City of Puyallup
Development & Permitting Services
ISSUED PERMIT

TACO TIME PUYALLUP

1115 EAST MAIN STREET PUYALLUP, WA 98372 PERMIT SET - 7.1.2022

① TRASH ENCLOSURE - PLAN
1/4" = 1'-0"

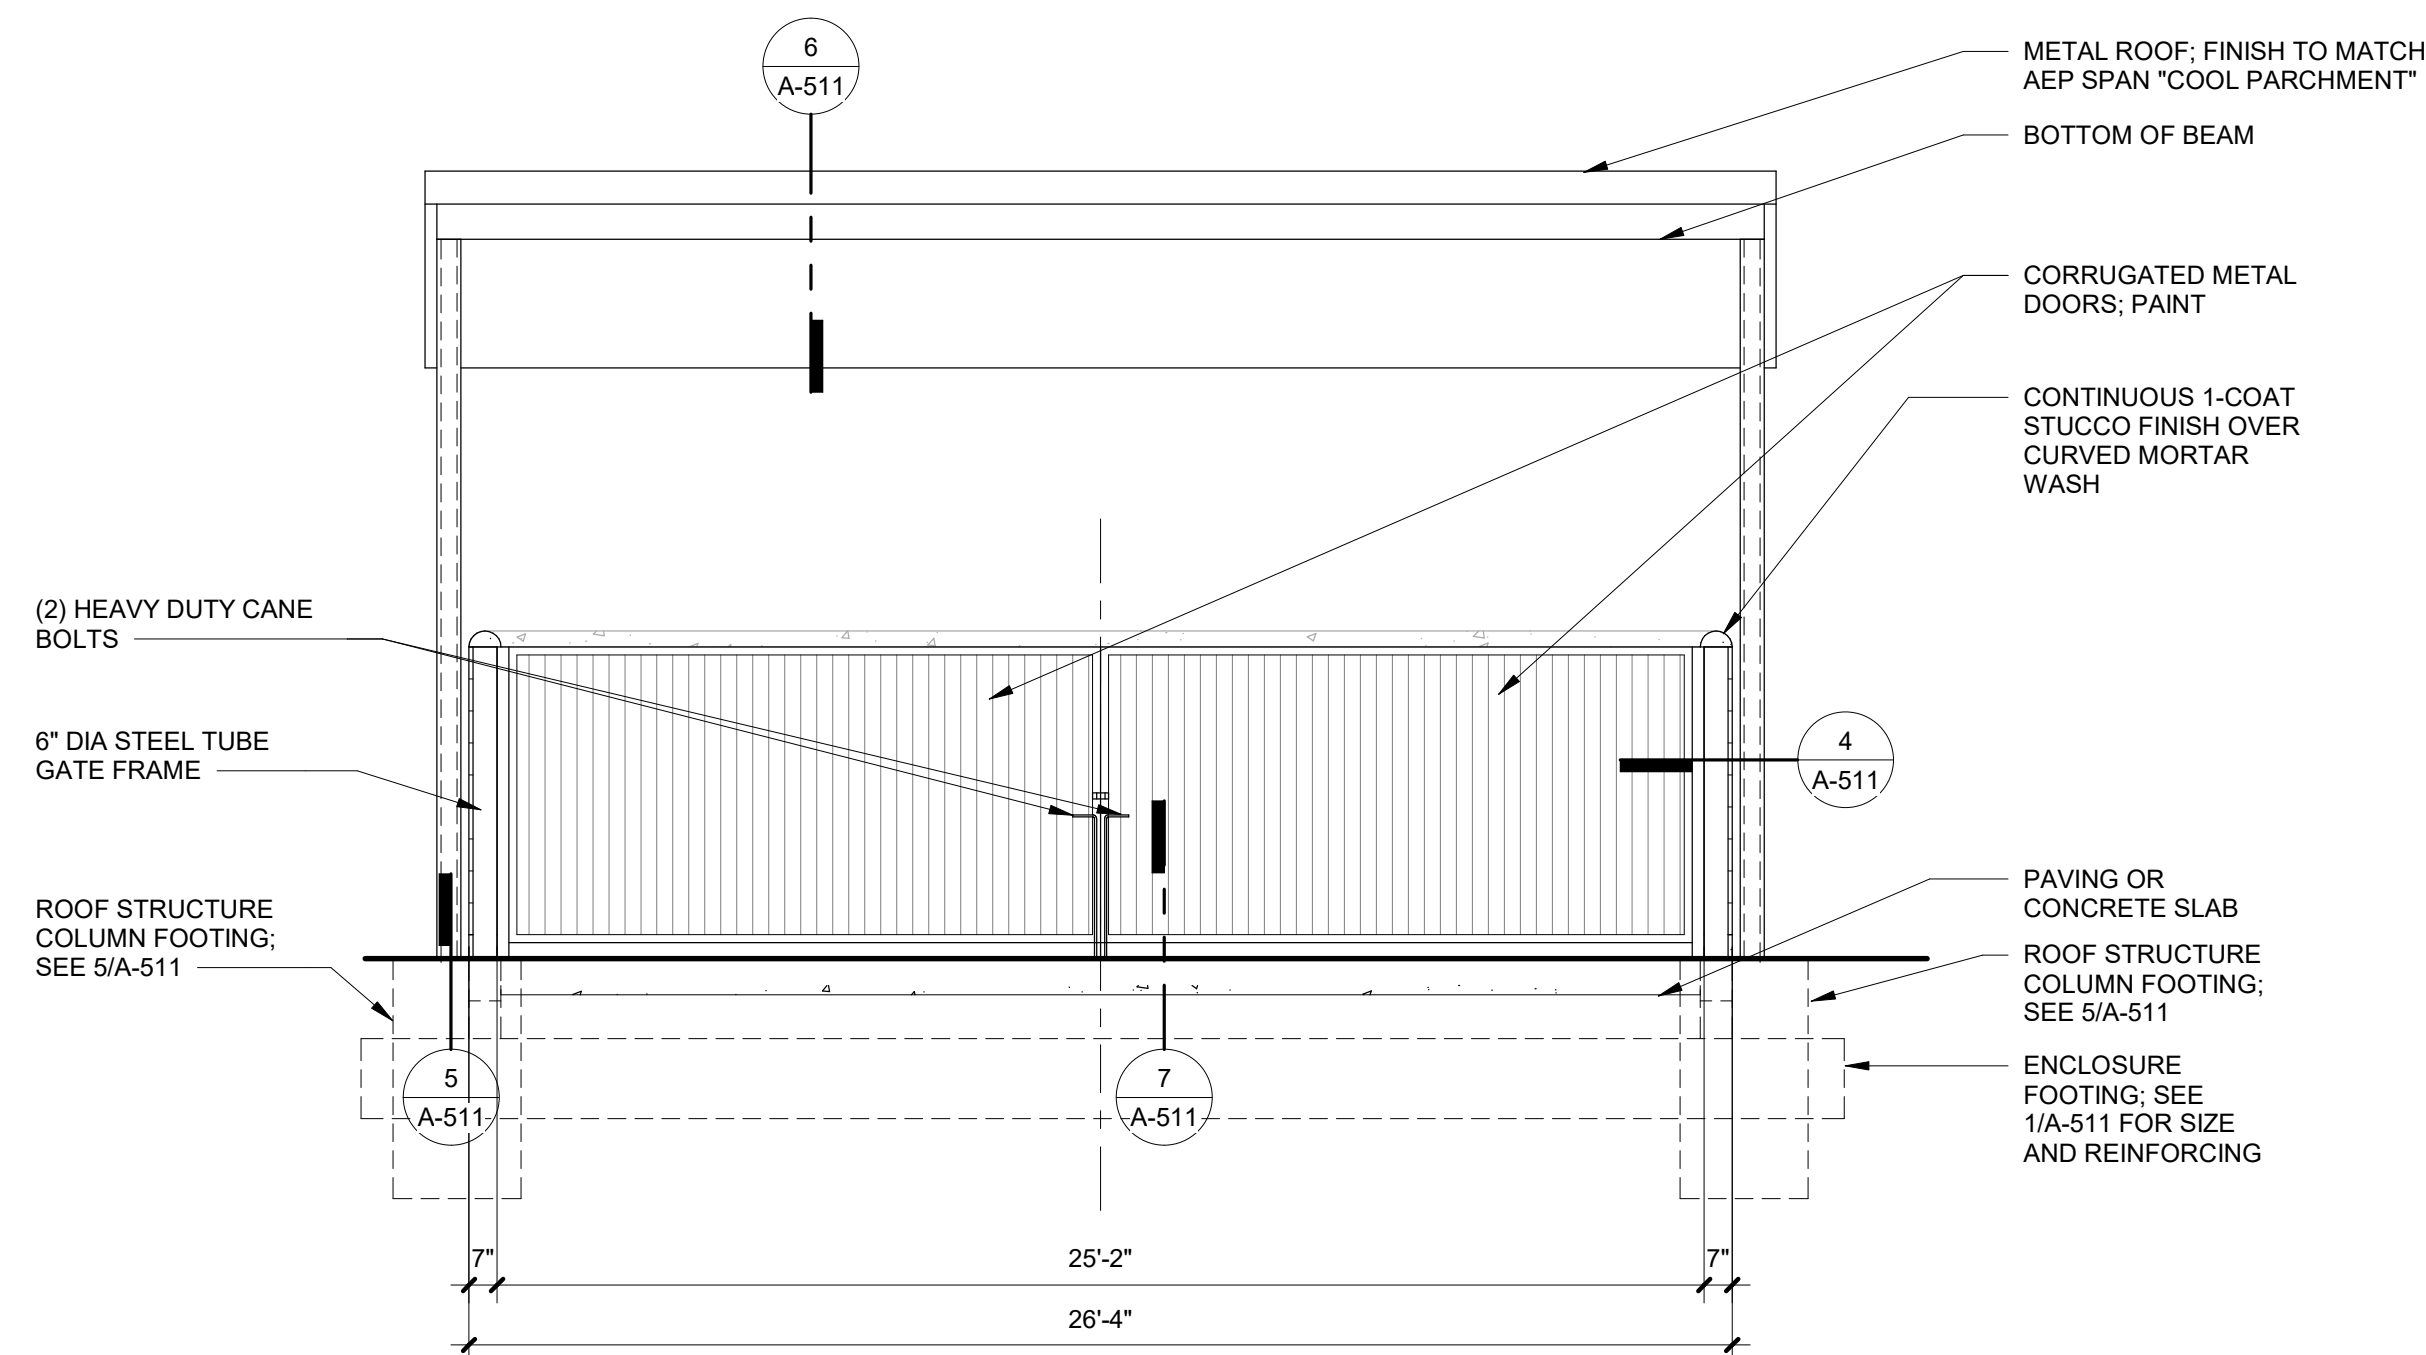
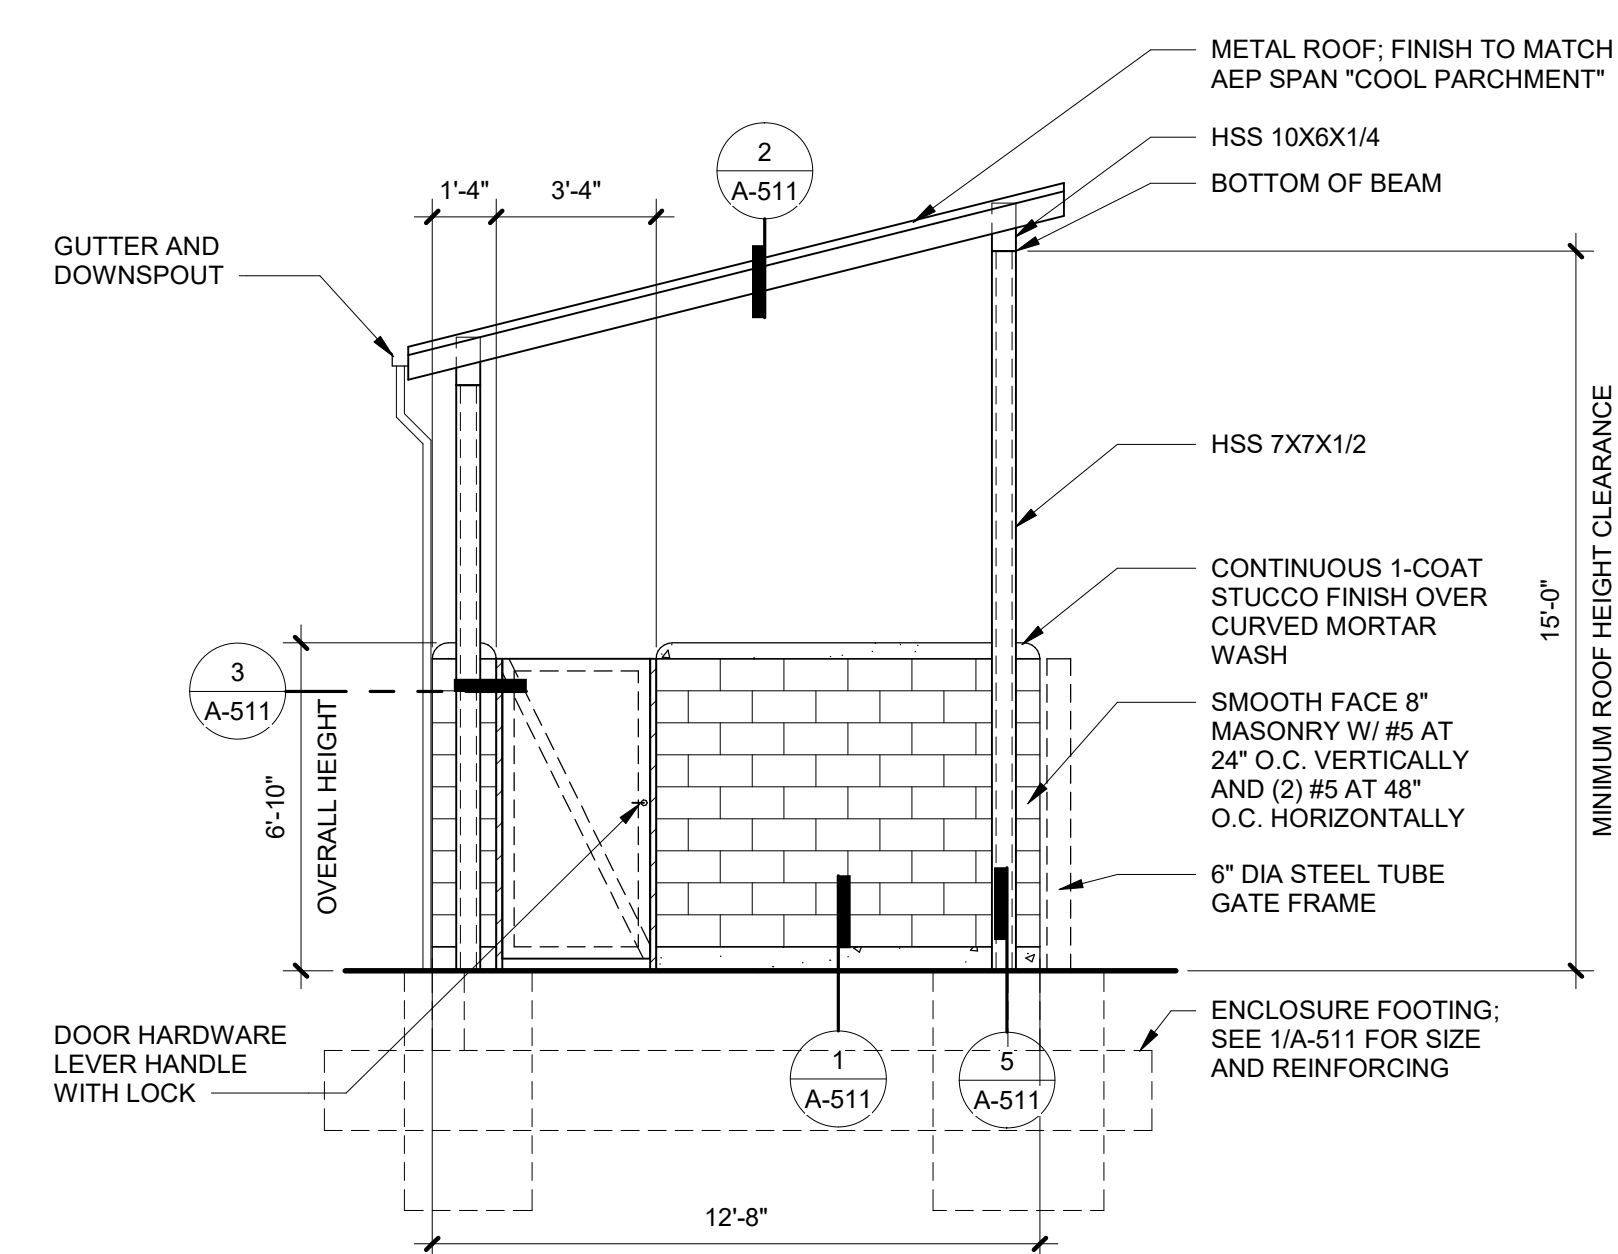
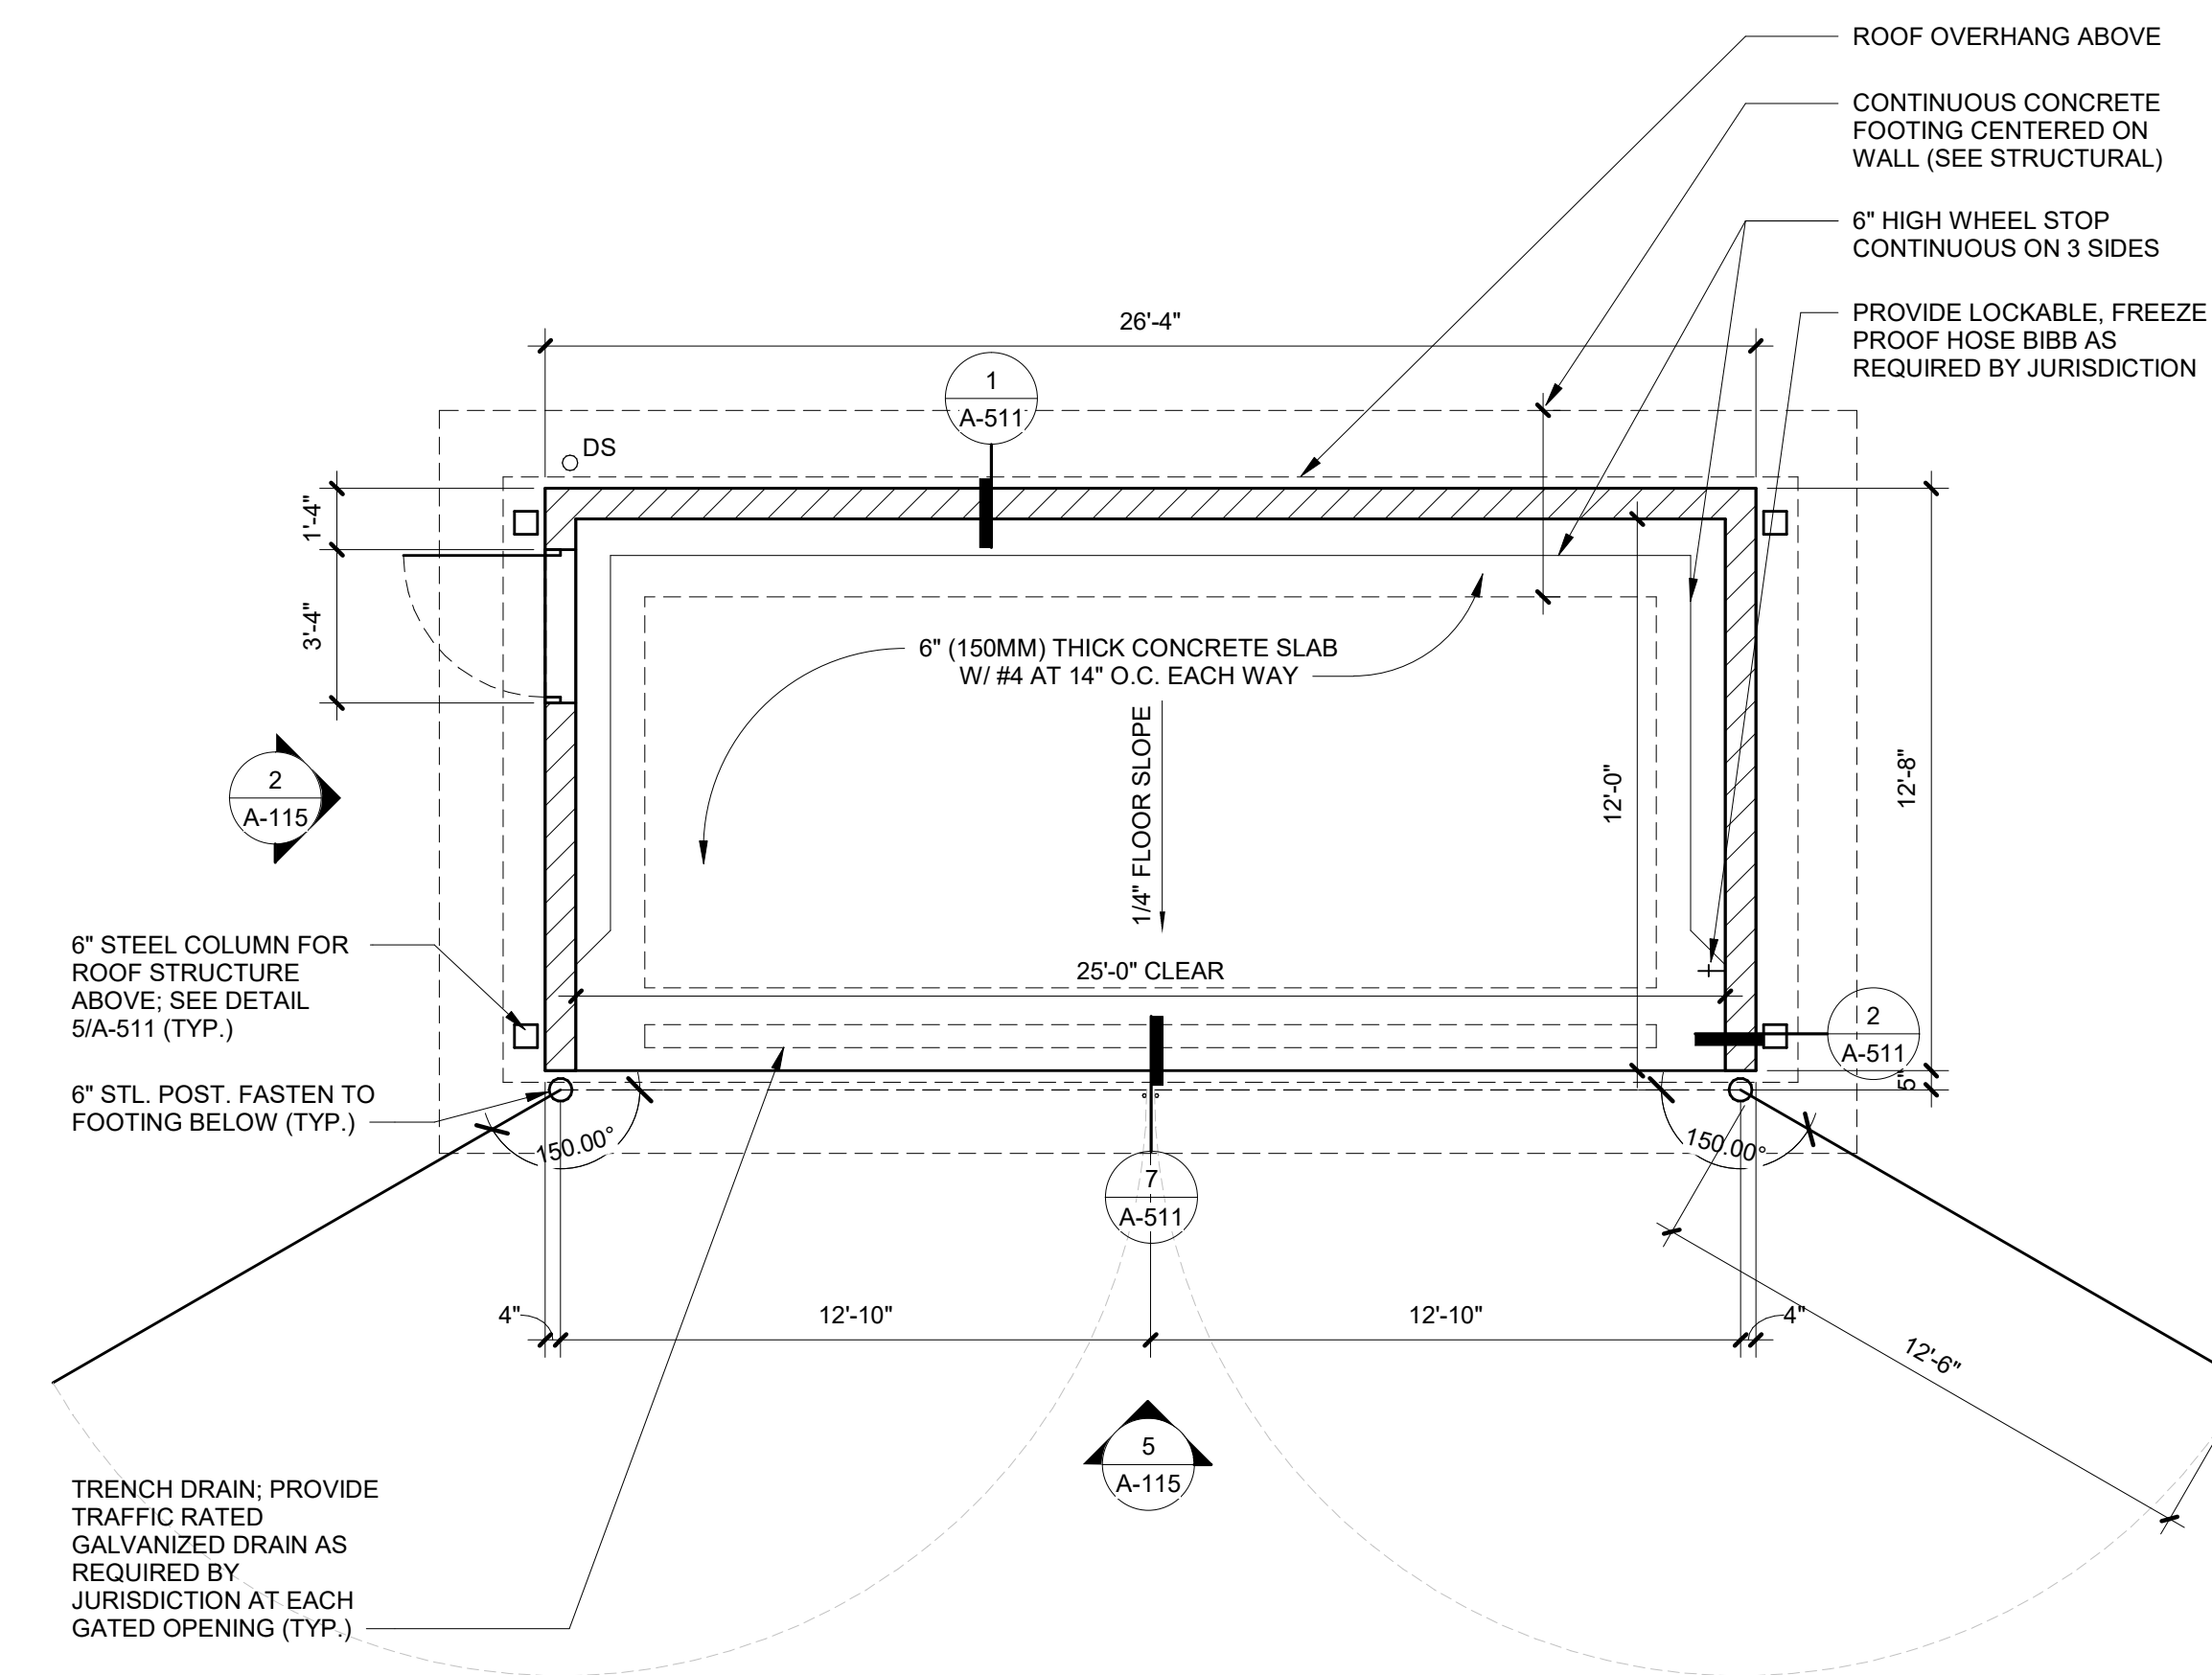
Trash enclosure will adhere to City Standard 208 Pollution Prevention

A grade break shall be provided around the trash enclosure to prevent runoff from entering the enclosure.

Stormwater control of the trash enclosure's roof downspouts must be controlled. See civil permit PRCCP20231136
